Blue Planet Fashion Wear Ltd.

13th January 2019 & 23rd January 2019.

Observations

Discrepancies Between Provided Drawing and On-Site Condition

Roof bracing layout

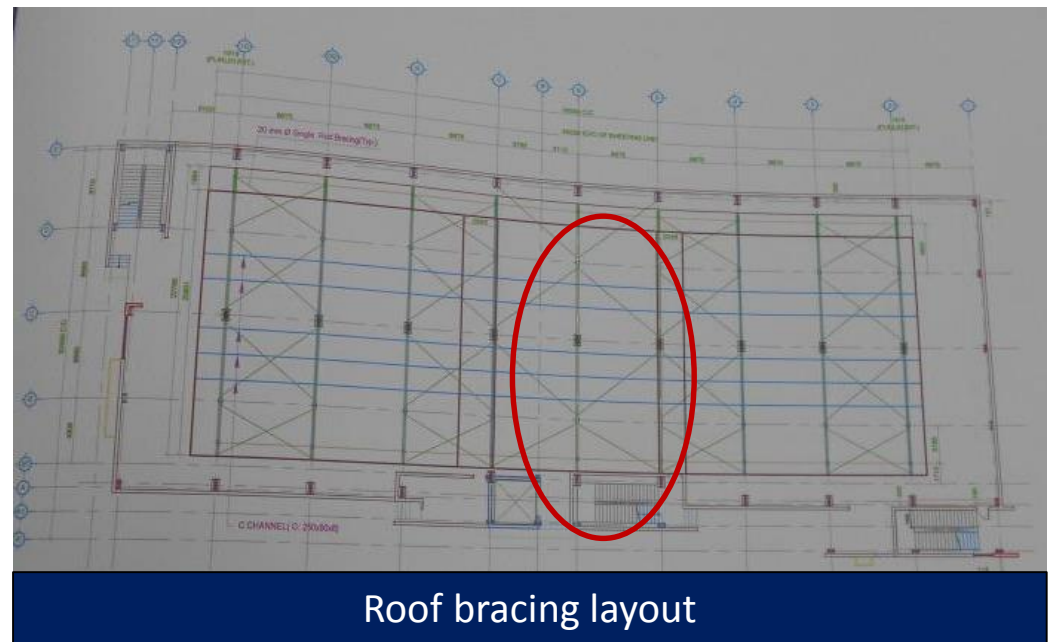
Red marked roof bracing is missing in on site.

On-site roof bracing between 5 to 7 grid was found different than the provided bracing layout drawing. Factory is required to install the roof bracing as per drawing otherwise provide Engineering Assessment for the roof shed.

Frame section of grid 5 & 7

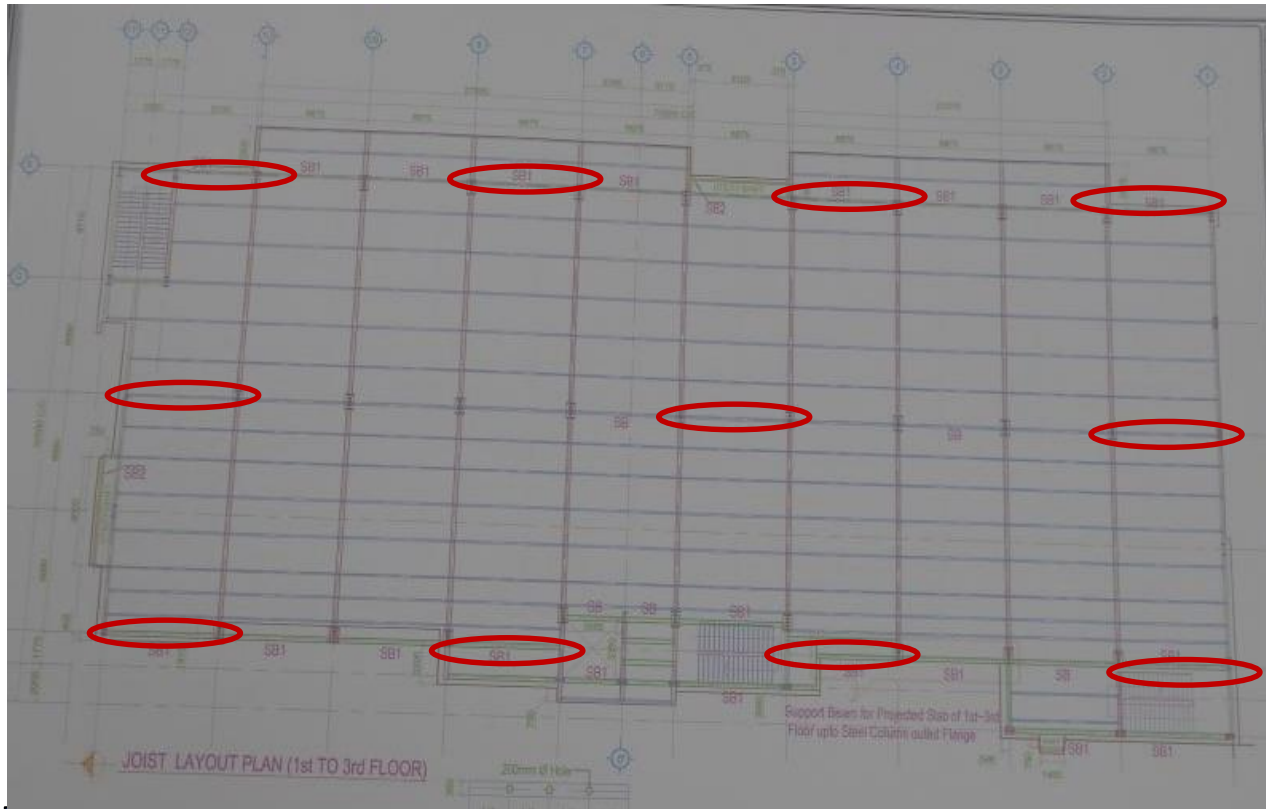
Red marked I joist was not installed in the grid of 5 & 7 as per the drawing. Factory engineer is required to install the missing members as per drawing otherwise provide Engineering Assessment for the roof shed.

Column Splice in roof

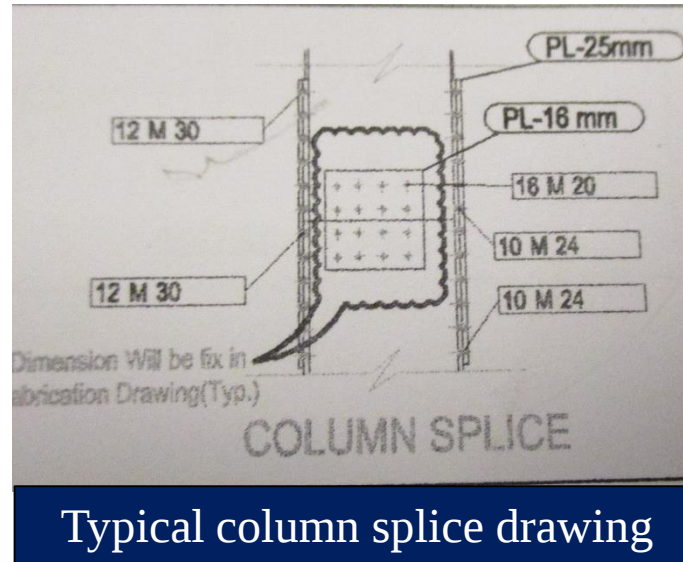
Design adequacy check required for the column splice connections

Typical column splice drawing

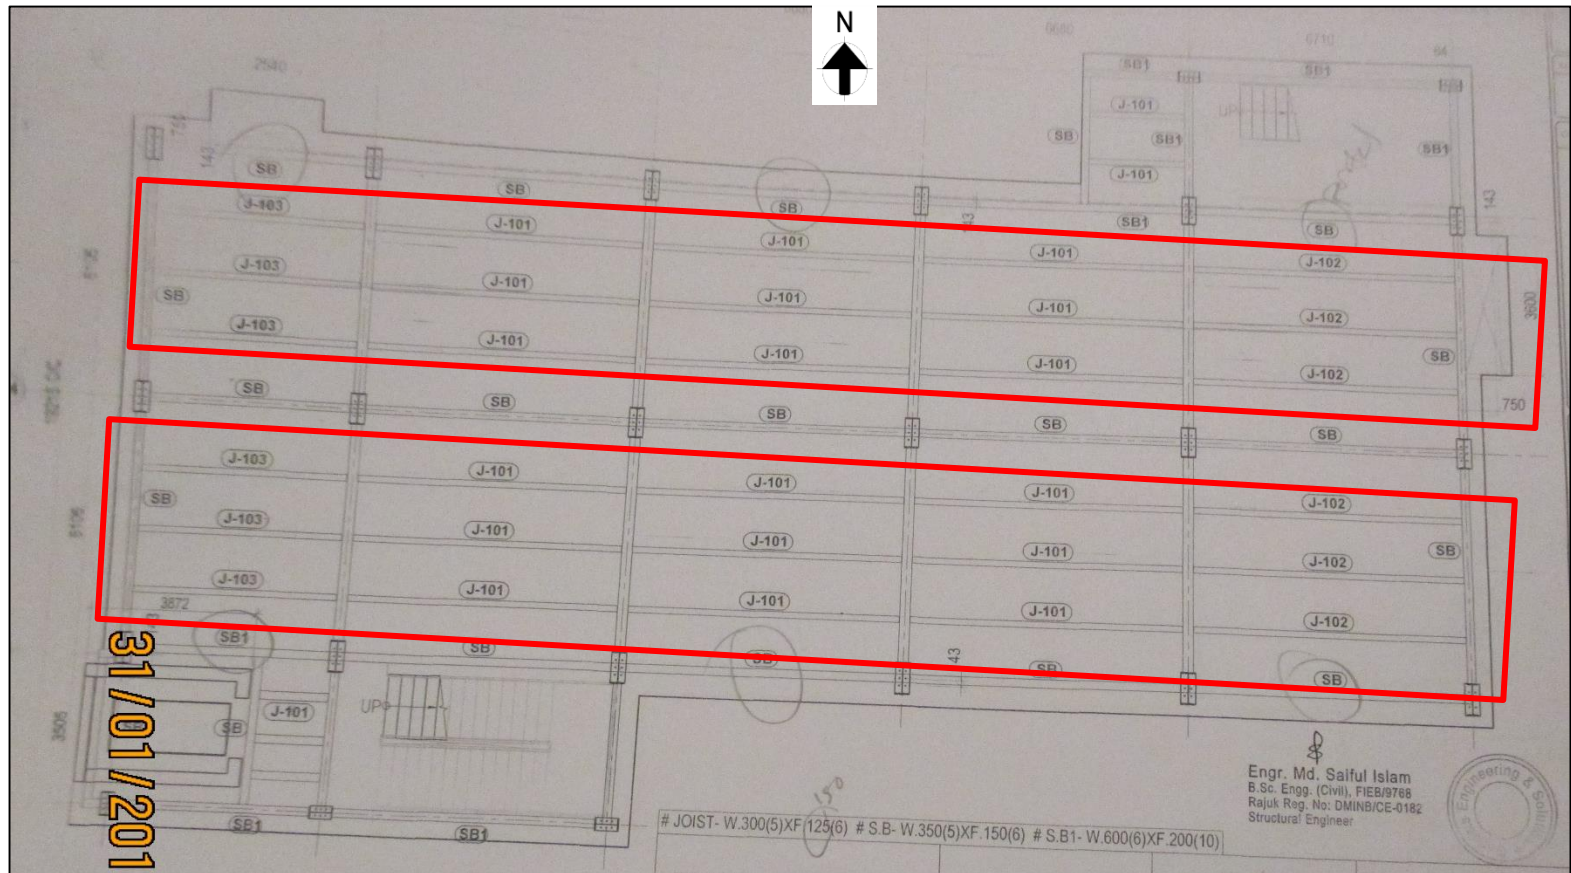
Discrepancies were observed in the column splice connections between as built drawing and on site structure. Factory is required to update the splice connection drawing and provide detail adequacy check of the connections.

Typical sub-beam layout

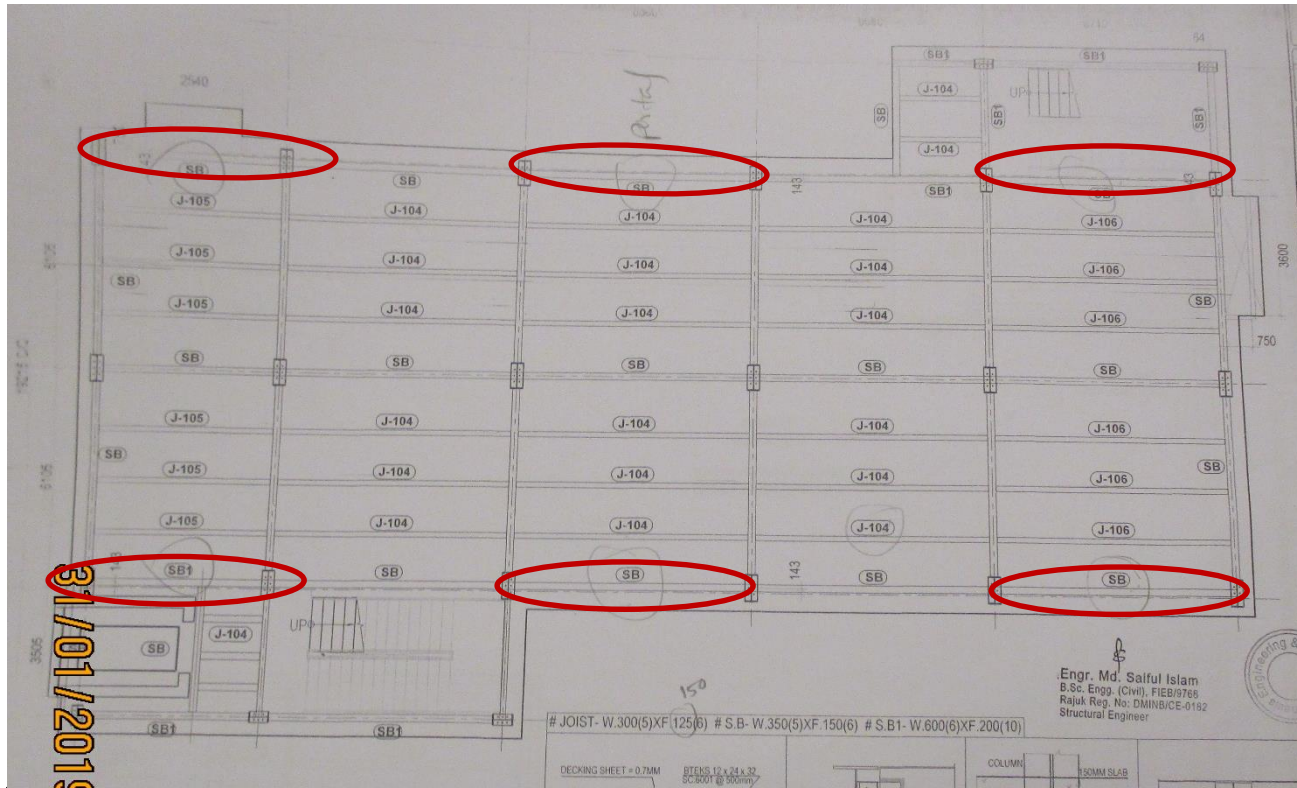
As per the sub-beam layout, sub-beam are shown W300x5x125x6 whereas on site condition shows the flange of the sub-beam 150 mm instead of 125 mm. Factory is required update the as built drawing.

Portal drawing

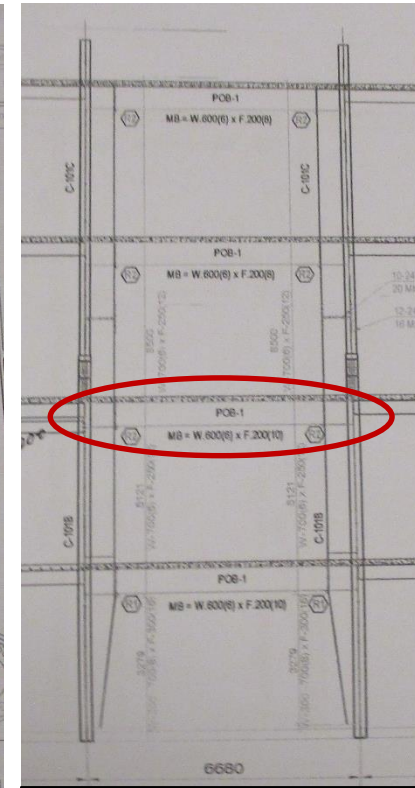
As per the sub-beam layout, sub-beam are shown in the portal position where no sub-beam exist in on-site condition. Factory is required to provide portal frame layout and revise the sub-beam and joist layout.
